## LAND-ROVER SERVICE NEWS LETTER No 44.

June, 1964

Item 213 SUBJECT: **CYLINDER HEAD FREE SERVICE MAINTENANCE ATTENTION**  
(Policy item)

Fig. 1. Order of tightening cylinder head bolts

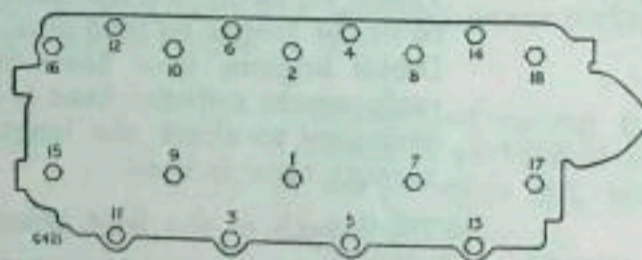
1. Ensure engine temperature is really hot.
2. Remove top rocker cover.
3. Disconnect feed pipe to each injector and slacken pipe at distributor pump end. Then swing pipes clear of injectors.
4. Disconnect spill pipe at rear of engine.
5. Remove injector clamping bars and lift injectors out as a complete set.
6. Check the cylinder head bolt tightness in the order indicated at Fig. 1, ensuring that all the  $\frac{1}{2}$  in. nuts and bolts are pulled down to 90 lb/ft. (12.5 mkg).

Fig. 2. Position of injector nozzle washers

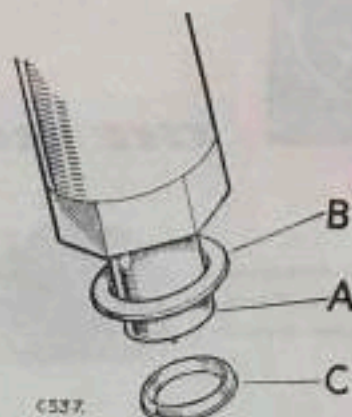
7. Check injectors as required.
8. Smear new injector copper joint washers with grease and fit one to each injector. Insert a new corrugated sealing washer into each injector nozzle recess in cylinder head with the raised portion upwards, then locate the injector nozzles; do not tighten the clamping bar fully at this stage. Ensure that the bottom seal washer (corrugated) is replaced correctly when refitting the injectors. See Fig. 2.
